ADDENDUM NO. 2

PROJECT NAME: Center for Brain, Biology and Behavior

UNL PROJECT NUMBER: C049P137

DATE OF ISSUANCE: July 17, 2012

Addendum #2
Supplemental Drawing: SDA-1
Revision of Sheet: A1.4
Date: 07/17/12

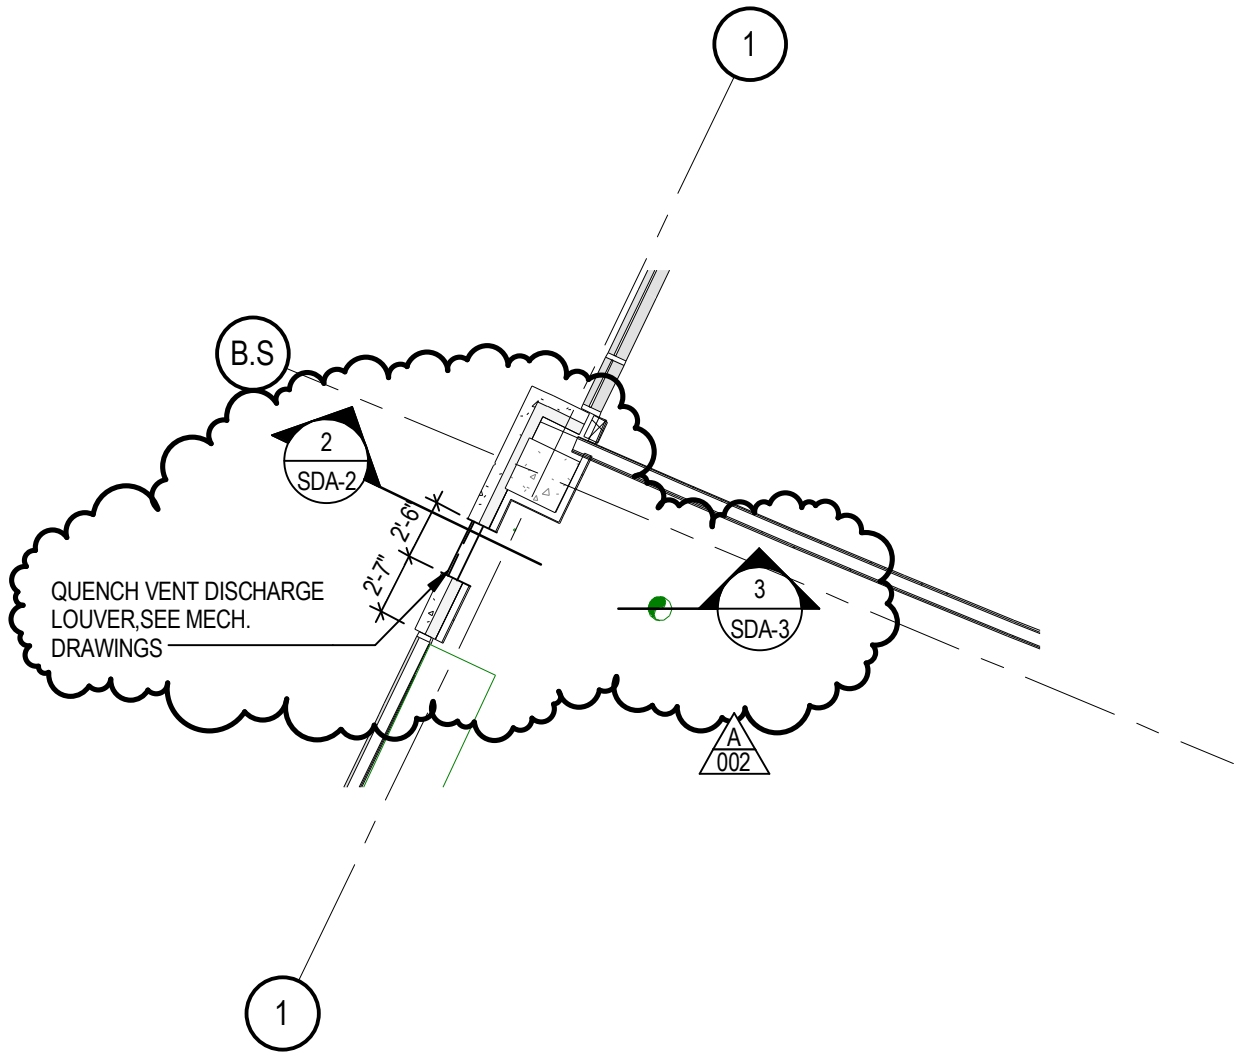
Item 2-21: Sheet A1.4 – MECHANICAL MEZZANINE PLAN

Refer to PARTIAL MECHANICAL MEZZANINE PLAN. Locate MRI quench vent and louver as indicated in attached supplemental drawing SDA-1, dated July 17, 2012. Coordinate requirements with mechanical plans.

Addendum #2
Supplemental Drawing: SDA-2
Revision of Sheet: A1.4
Date: 07/17/12

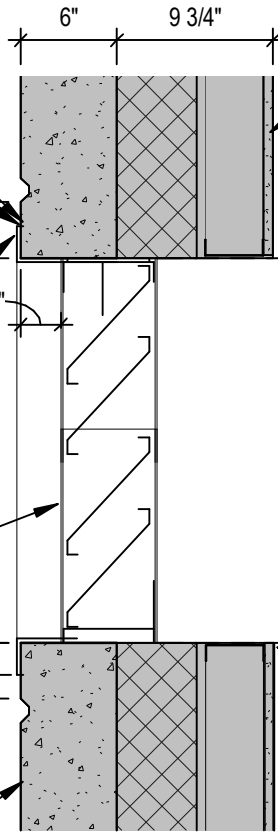
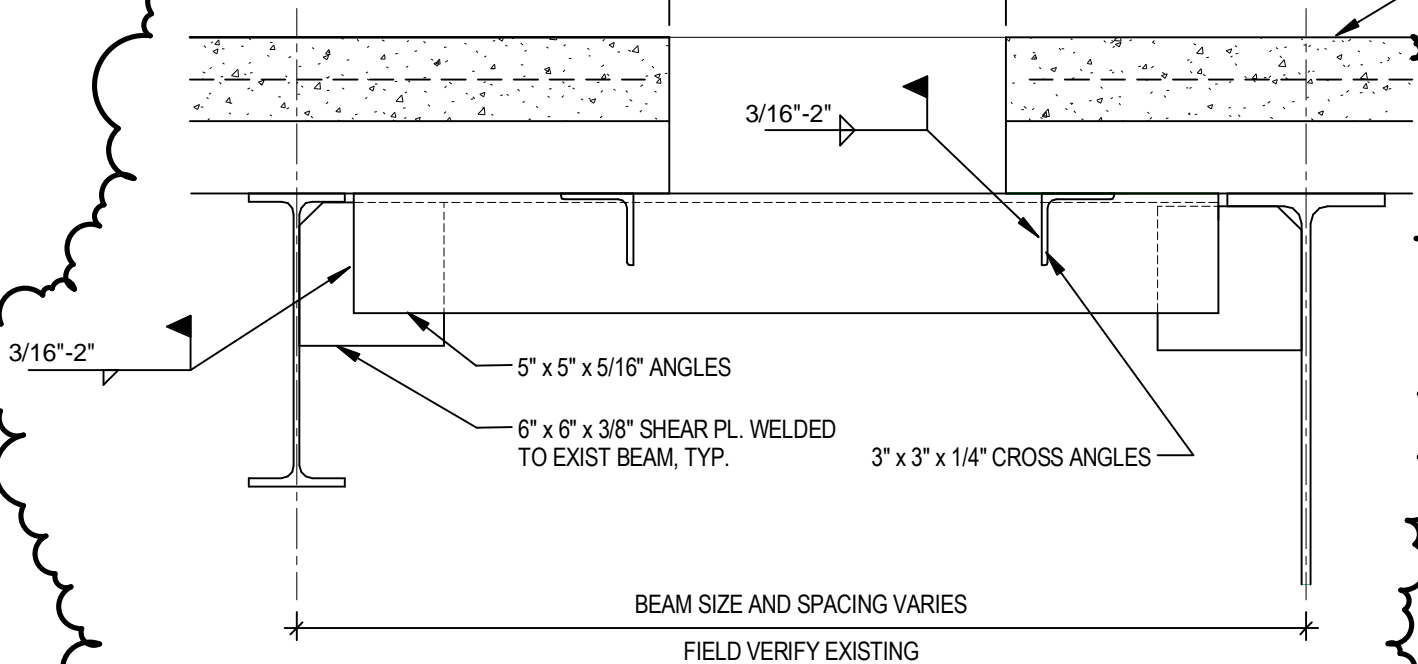
Item 2-22: Sheet A1.4 – MECHANICAL MEZZANINE PLAN

Add detail 2 – QUENCH VENT DISCHARGE SECTION as indicated in attached supplemental drawing SDA-2, dated July 17, 2012.

3 MECH PENETRATION DETAIL

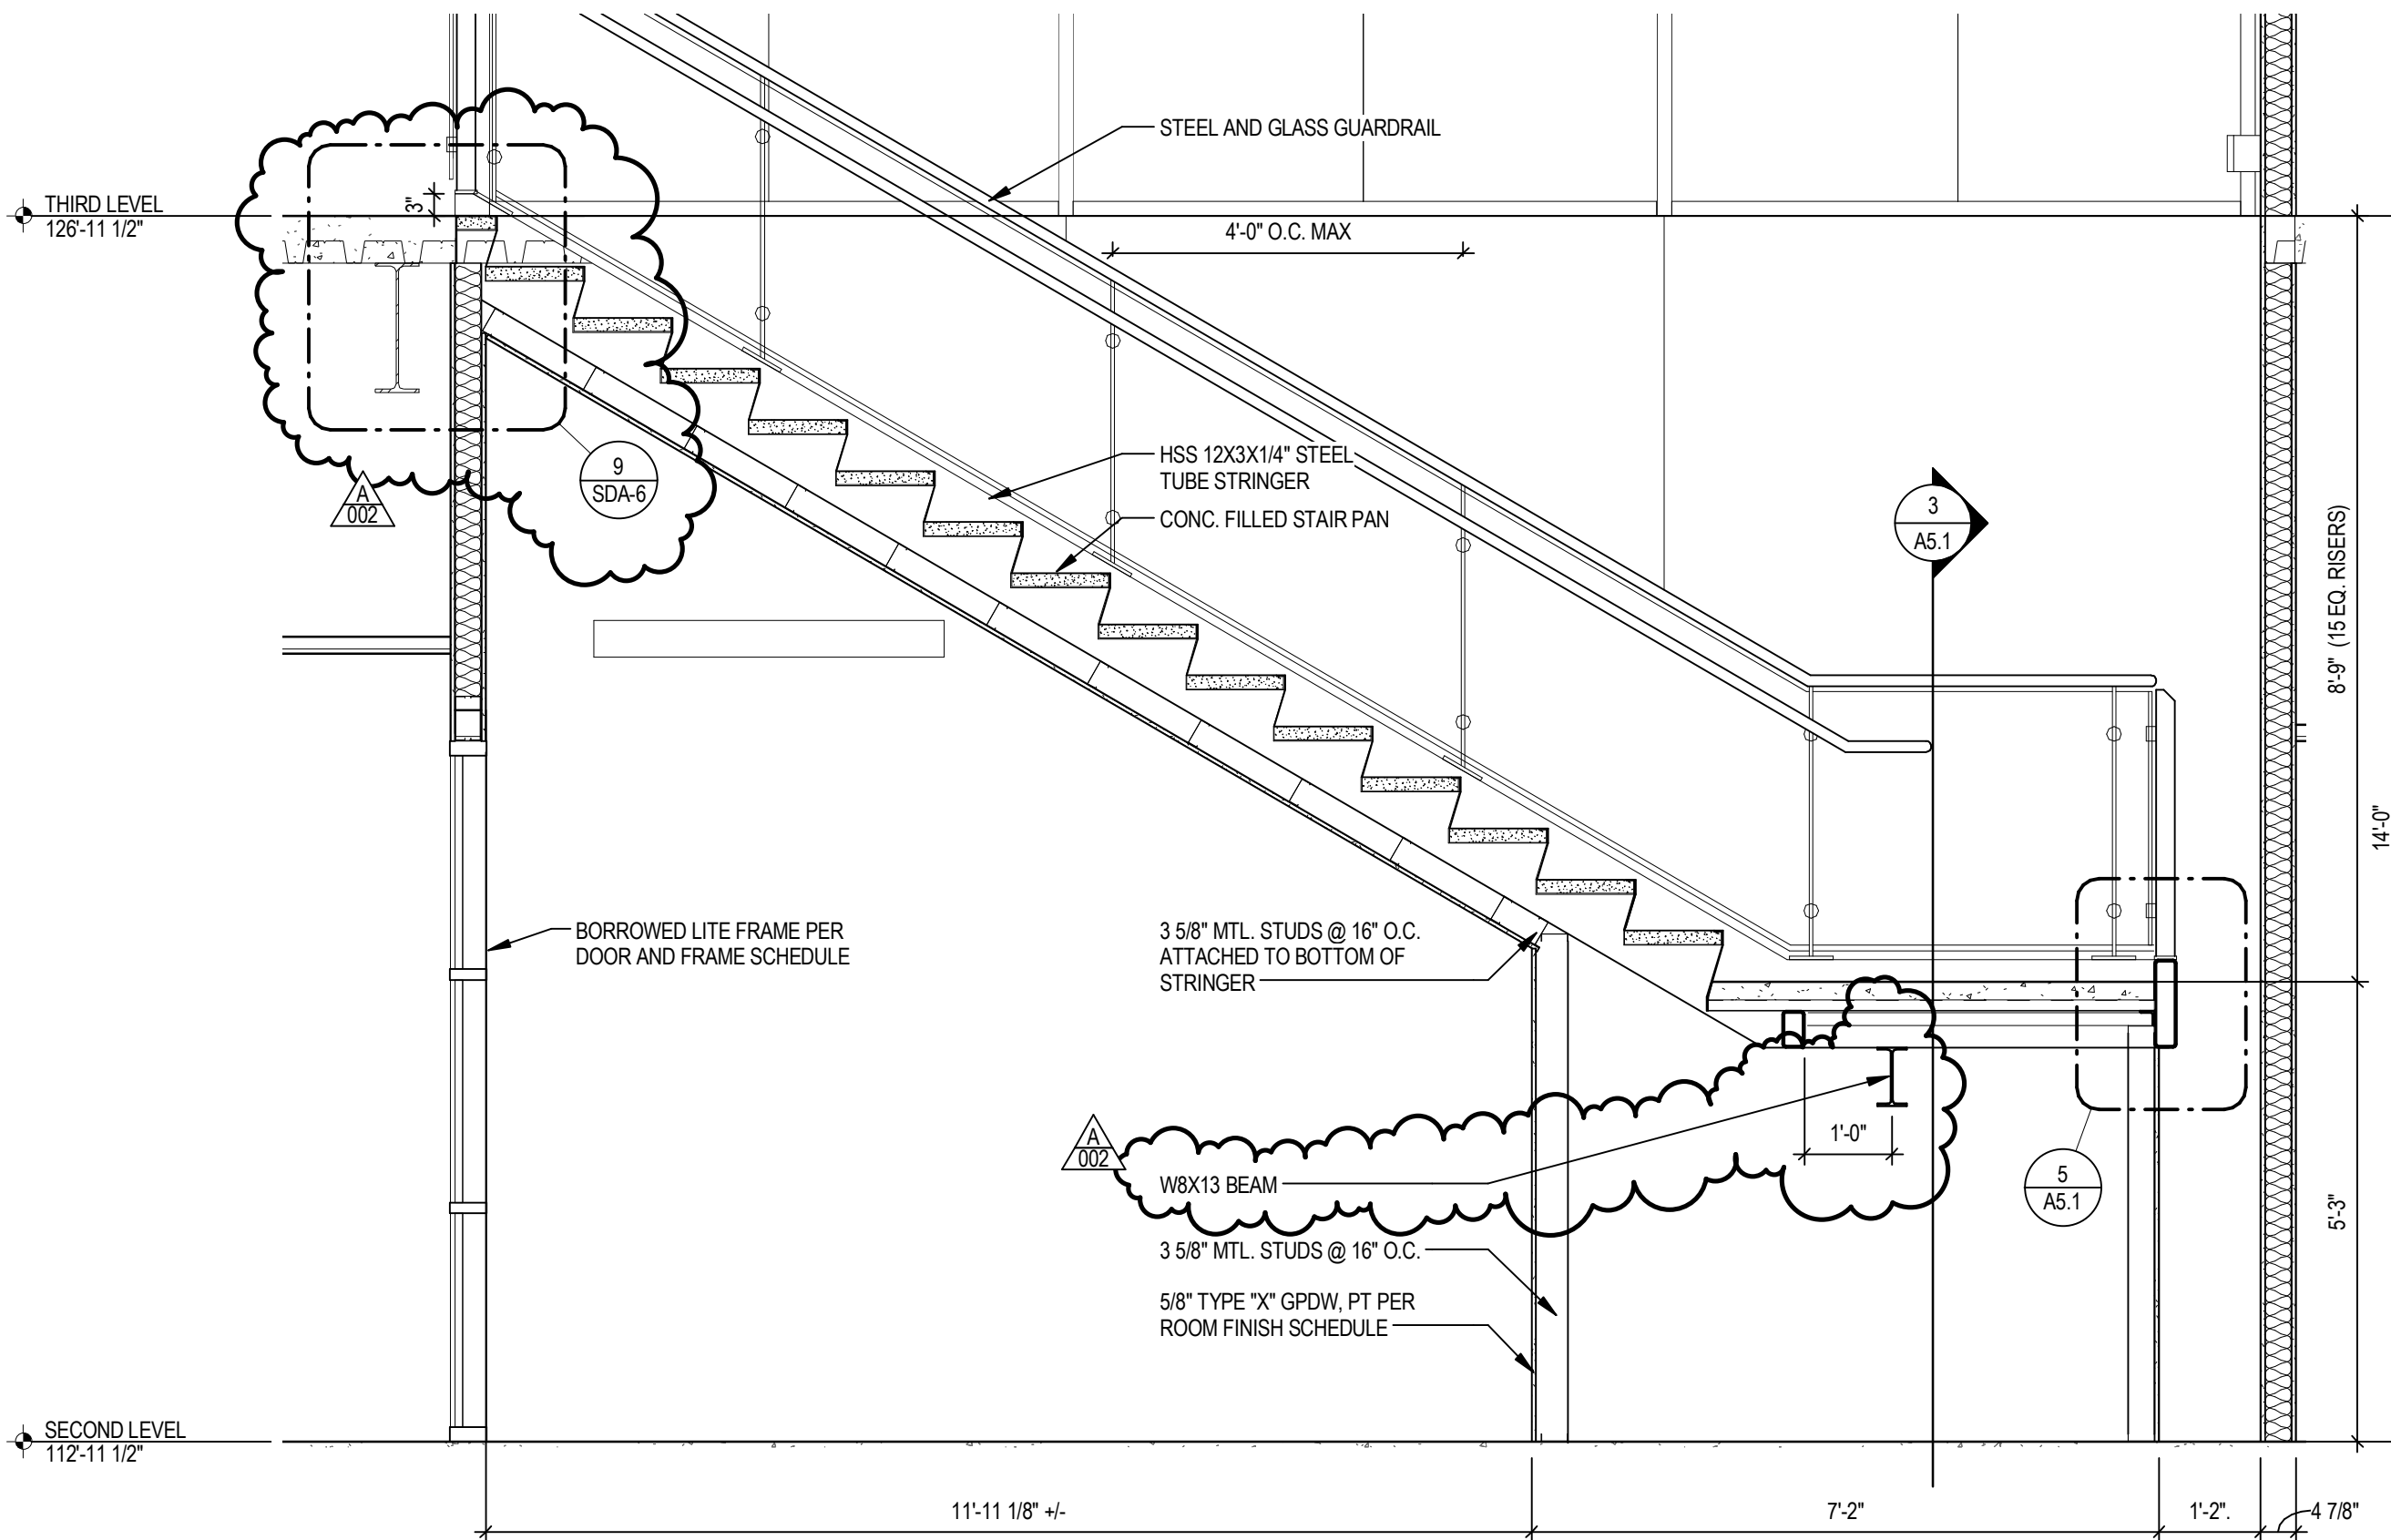
Item 2-23: Sheet A1.4 – MECHANICAL MEZZANINE PLAN

Add detail 3 – MECHANICAL PENETRATION DETAIL as indicated in attached supplemental drawing SDA-3, dated July 17, 2012.

2 PARTIAL STAIR SECTION - REVISED

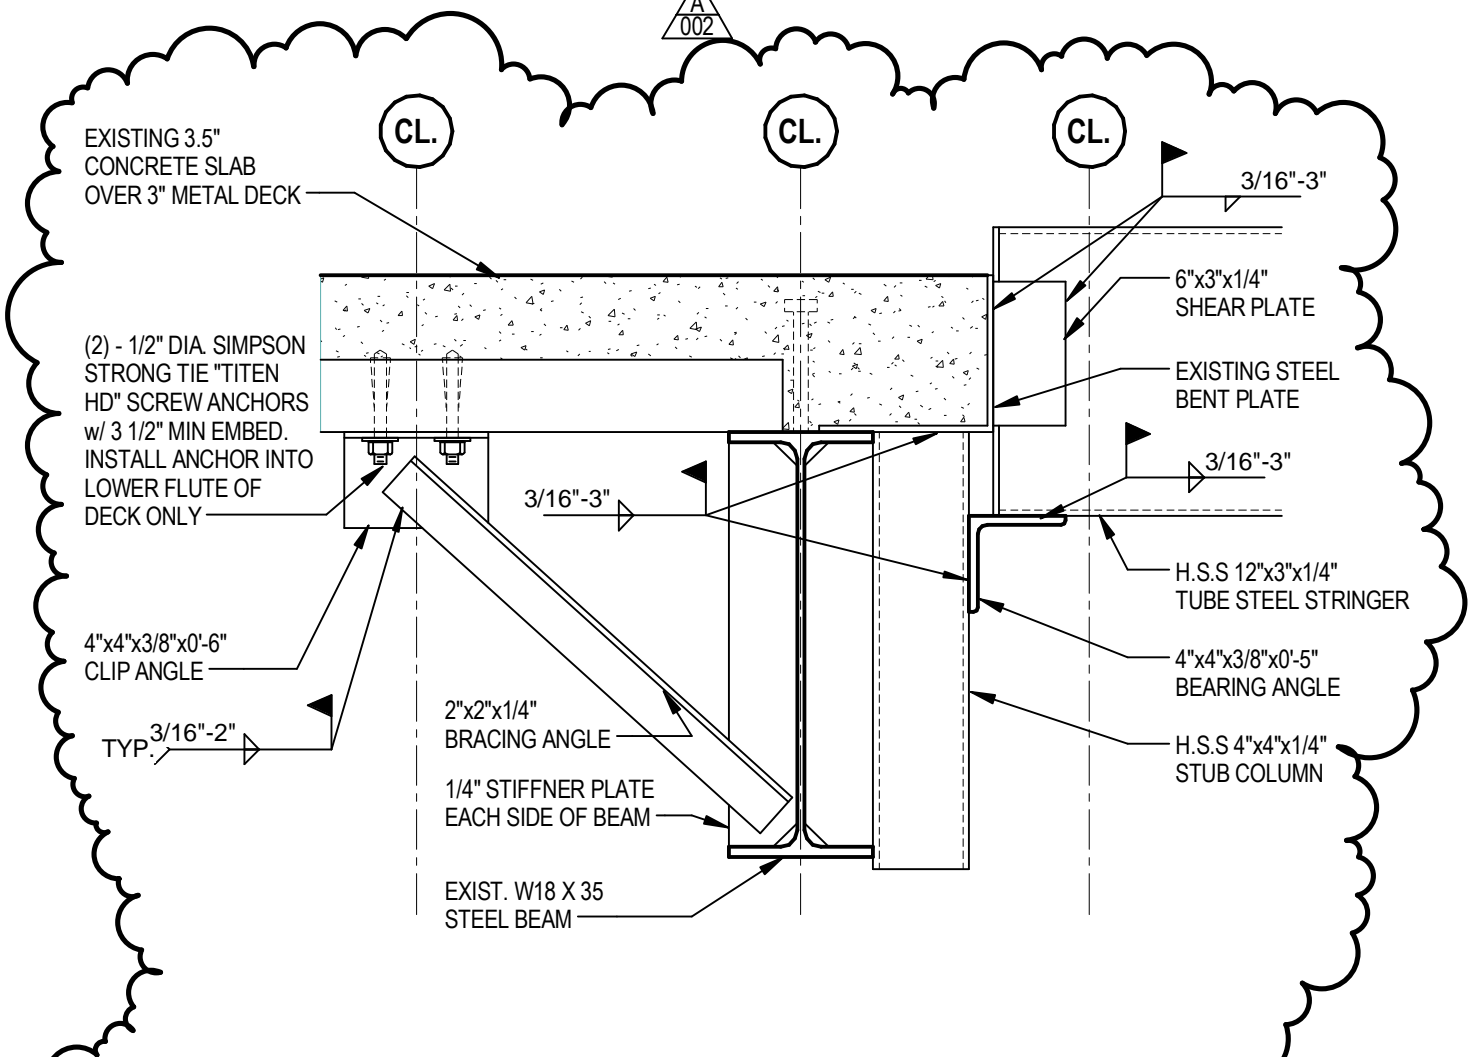
Item 2-25: Sheet A5.1 – ENLARGED STAIR PLAN, SECTIONS, AND DETAILS

Refer to detail 2 STAIR SECTION. Add annotations as indicated in attached supplemental drawing SDA-5, dated July 17, 2012.

9 STRINGER SUPPORT DETAIL

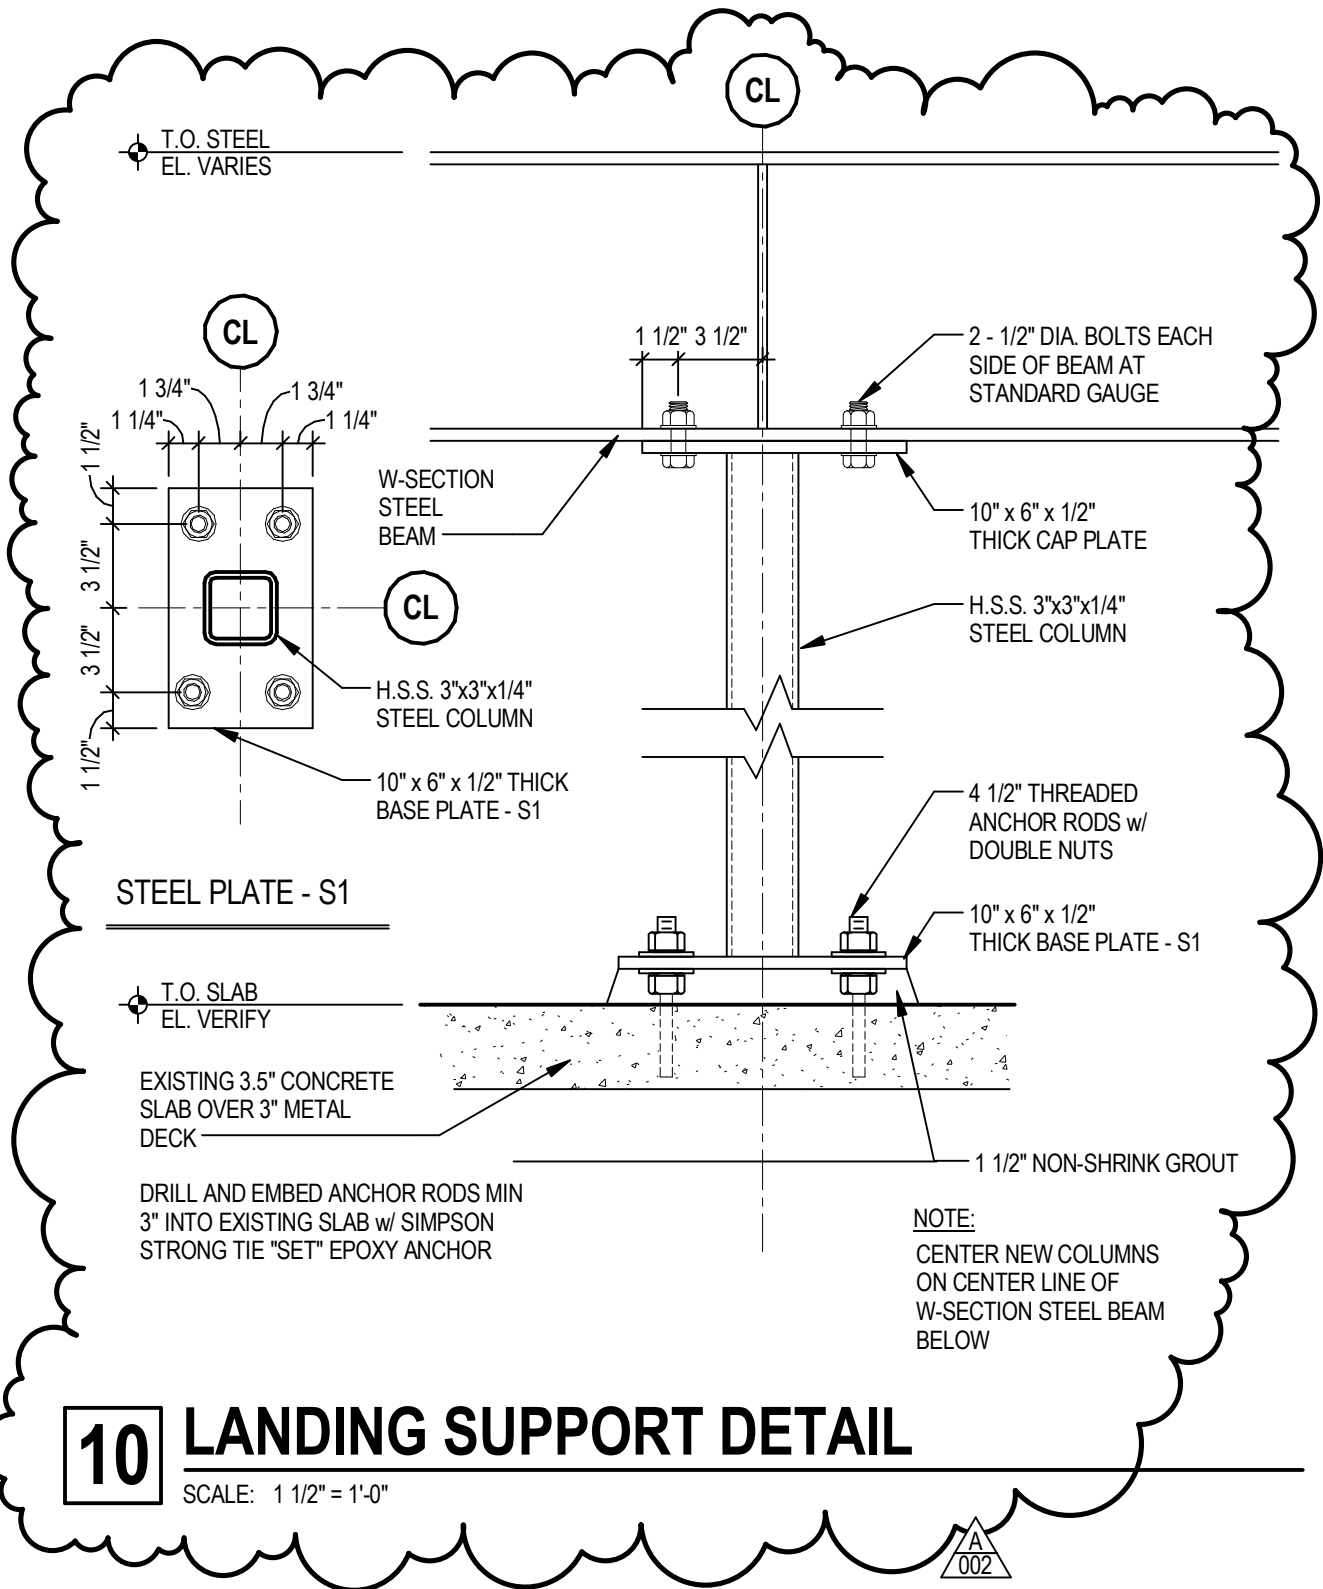
Item 2-26: Sheet A5.1 – ENLARGED STAIR PLAN, SECTIONS, AND DETAILS

Add detail 9 – STRINGER SUPPORT DETAIL as indicated in attached supplemental drawing SDA-6, dated July 17, 2012.

Addendum #2
Supplemental Drawing: SDA-7
Revision of Sheet: A5.1
Date: 07/17/12

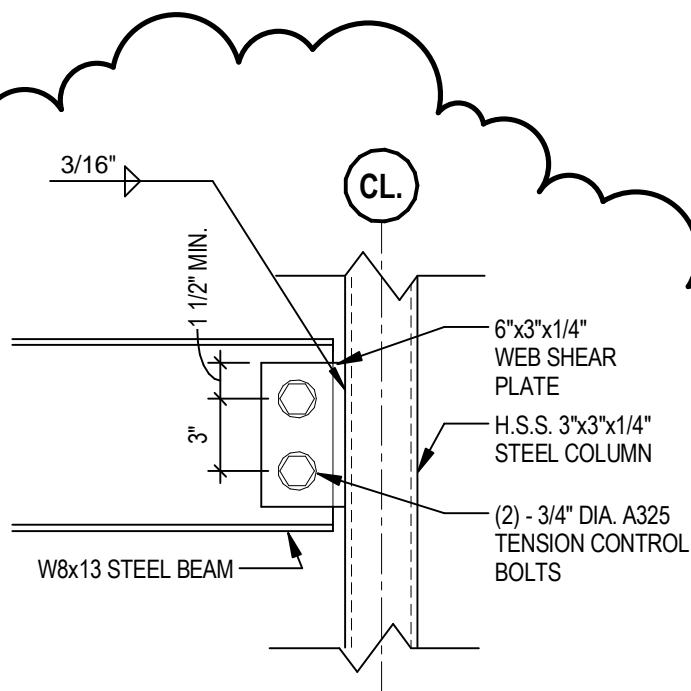
Item 2-27: Sheet A5.1 – ENLARGED STAIR PLAN, SECTIONS, AND DETAILS

Add detail 10 – LANDING SUPPORT DETAIL as indicated in attached supplemental drawing SDA-7, dated July 17, 2012.

LANDING SUPPORT CONNECTION DETAIL

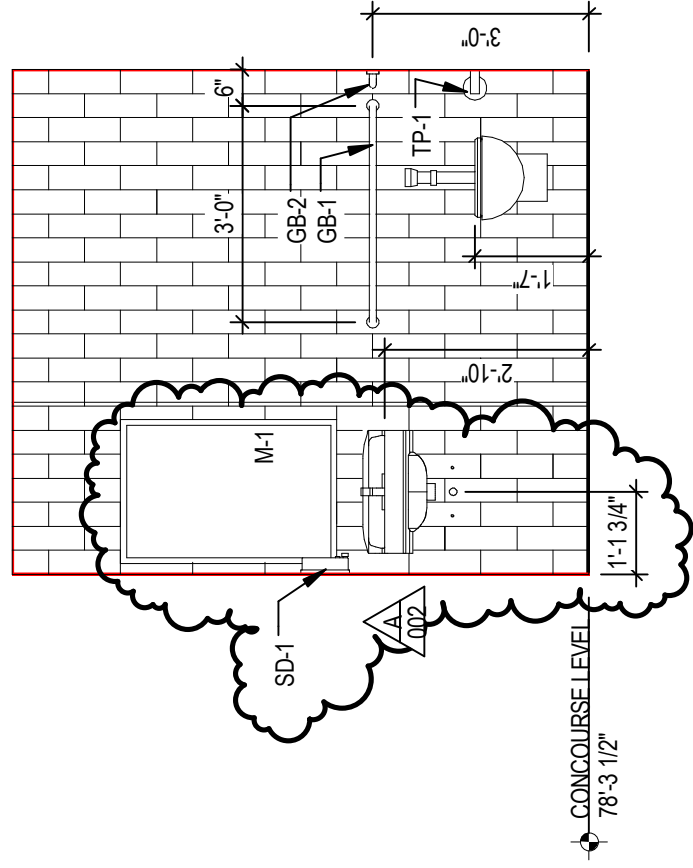
Item 2-28: Sheet A5.1 – ENLARGED STAIR PLAN, SECTIONS, AND DETAILS

Add detail 12 – LANDING SUPPORT DETAIL as indicated in attached supplemental drawing SDA-8, dated July 17, 2012.
